Airport Moving Map Alert

Subject: An Giang, Vietnam
Phu Quoc Intl (VVPQ)
Cycle 2609

RWY 10/28 information incorrect

10. APR. 26 (10-9) Eff 16 Apr

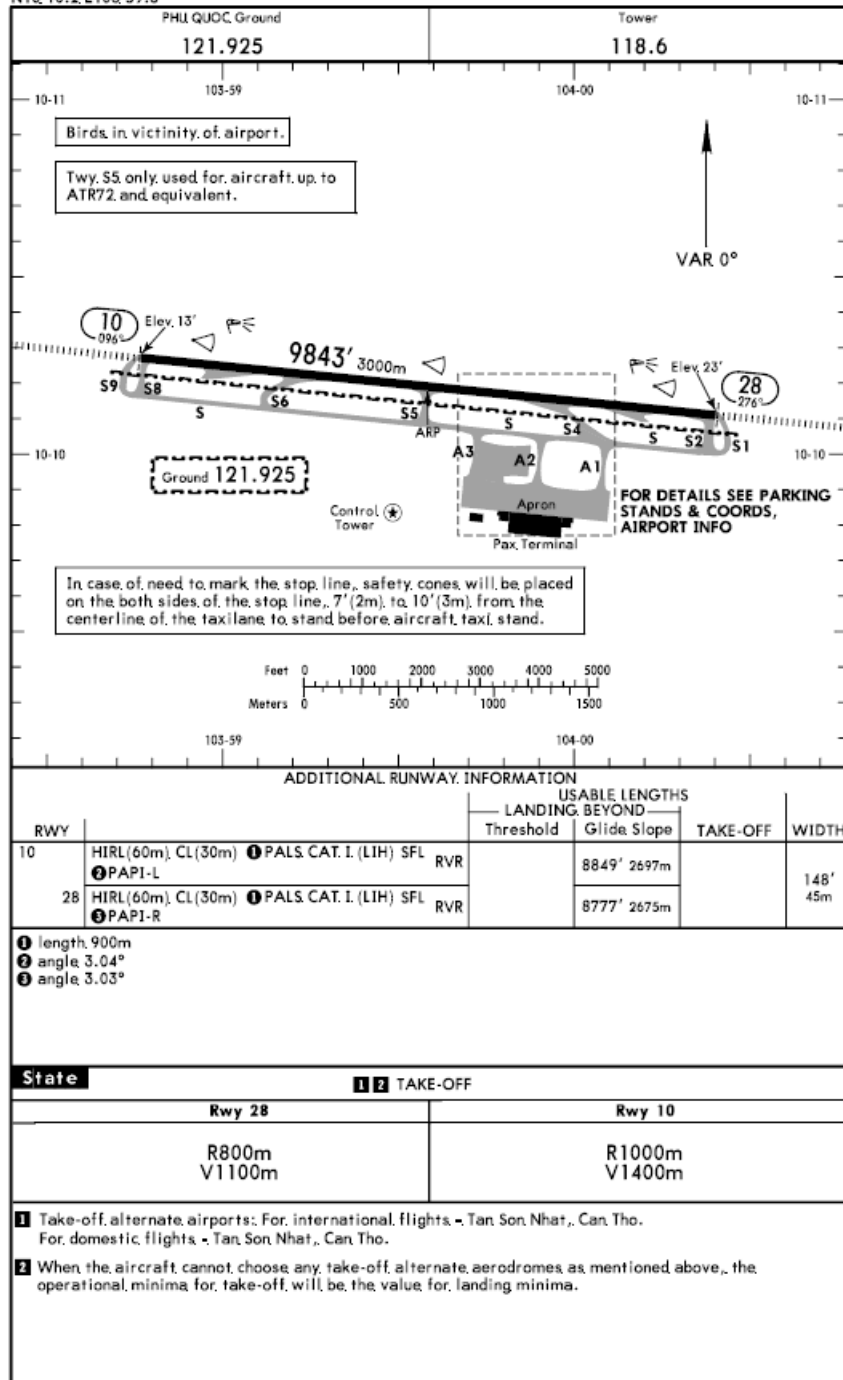
Jeppesen Airport Moving Map and A816 formatted data for cycle 2609, effective 03 September 2026 contains incorrect data for Phu Quoc Intl; An Giang, Vietnam (VVPQ). NOTAM A2896/26 was received after the ICAO specified date for aeronautical information publication and postpones the introduction of new Runway 10L/28R until 01 October 2026.

Therefore, the only operational Runway available until 30 September 2026 is Runway 10/28.

As a result, the following changes are not reflected in cycle 2609 data:

- RWY 10R/28L shall read **RWY 10/28**
- RWY 10L/28R is closed
- TWYs B1, B10, D, D1, D7-D12, D14 are closed

Revised data will appear in Jeppesen Airport Moving Map and A816 formatted data for cycle 2610, effective 01 October 2026. Until then this Alert will be posted on the Jeppesen Web site: [Notices and Alerts](#). Please refer to the local NOTAMs and attached An Giang, Vietnam (VVPQ) 10-9 chart dated 10 MAY 26, effective 16 APR 26 for valid information.
